**Subject: Compliance Recall Campaign Q8 (07V-442)**

Subject: Compliance Recall Q8  
Headlamp Inspection/Modification

**Headlamp Inspection/Modification**

#### Section A – Inspect Headlamp for Cap – Horizontal Adjuster (Halogen and Xenon Headlamps)

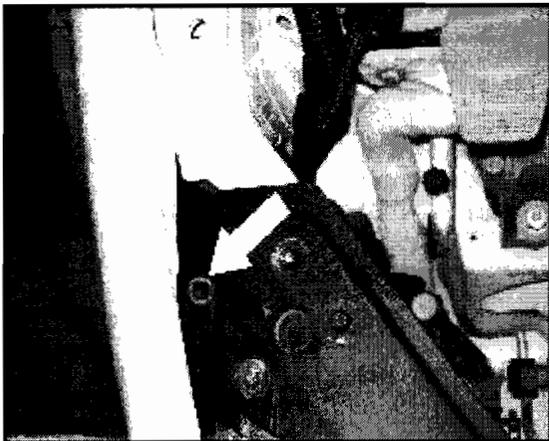
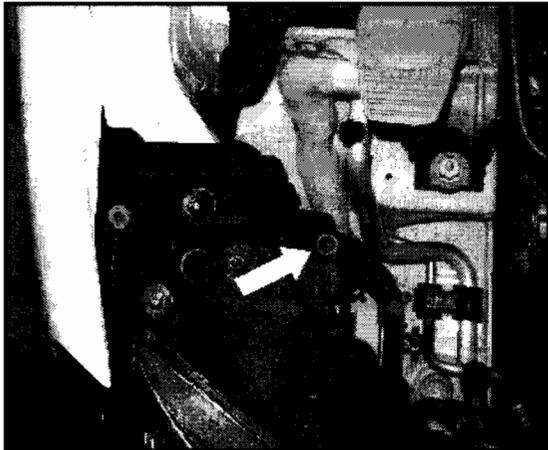
- Locate either headlamp on vehicle
- Visually inspect the horizontal headlamp adjuster by looking between the fender and headlamp bucket (as shown here) -arrow-

- If cap is present on horizontal headlamp adjuster, **proceed to Section B**

⇐ Install cap (4E0 941 041) into adjuster hole -arrow- and press firmly to ensure proper seating, **proceed to Section B**

### Section B - Inspect Headlamp For Incorrect Cap Position – Vertical Adjuster (Halogen and Xenon Headlamps)

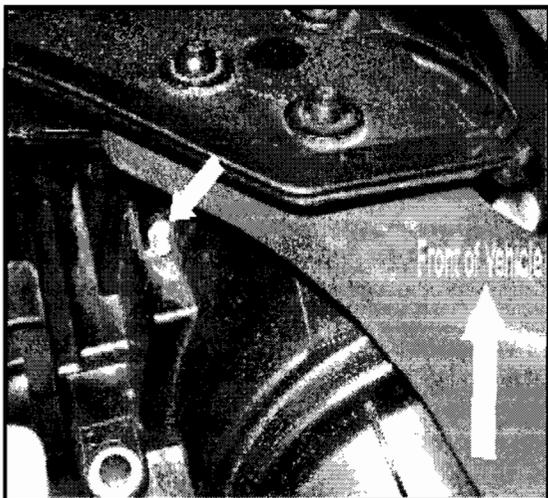
- ⇐ If cap is present on headlamp vertical adjuster -arrow-, punch hole in cap and remove cap using needle nose pliers
- If cap is not present on headlamp vertical adjuster -arrow-, **proceed to Section C for Xenon headlamps or Section D for Halogen headlamps**

### Section C - Inspect For Covered Diagonal Adjuster (XENON Headlamps Only)

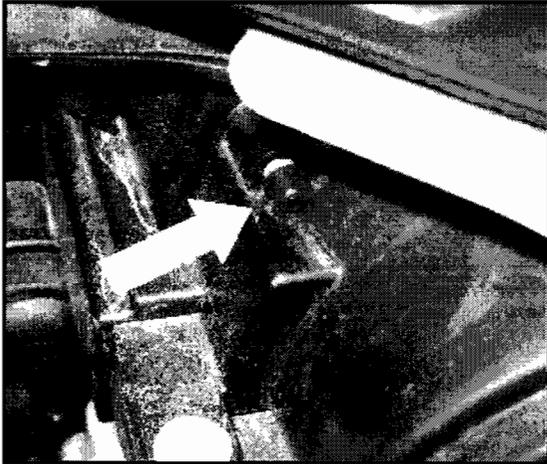
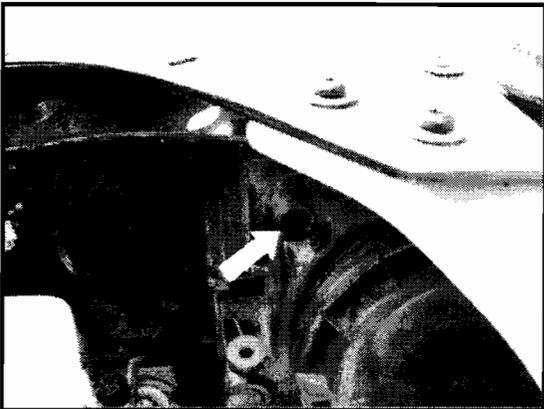
- ⇐ If headlamp diagonal adjuster on back of headlamp -arrow- is not covered, install plastic cover

⇐ If headlamp diagonal adjuster on back of headlamp is already covered, **no further work required**

⇐ Install plastic cover (000 941 041A) onto adjuster and press firmly -arrow-; **no further work required**

#### **Section D - Inspect For Covered Diagonal Adjuster (HALOGEN Headlamps Only)**

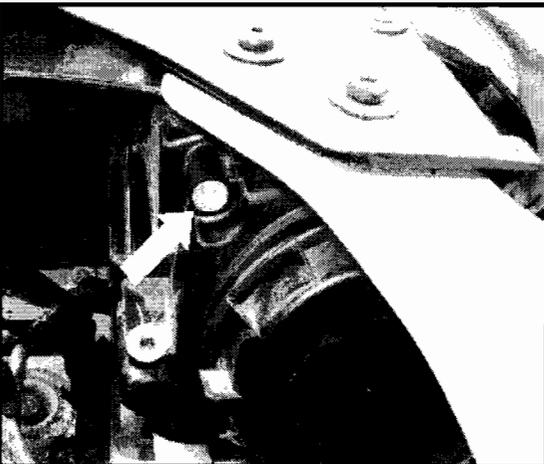
⇐ If headlamp diagonal adjuster on back of headlamp is not covered -arrow-, install plastic cover

⇐ Install plastic cover (000 941 041) on rearward facing headlamp adjuster -arrow-
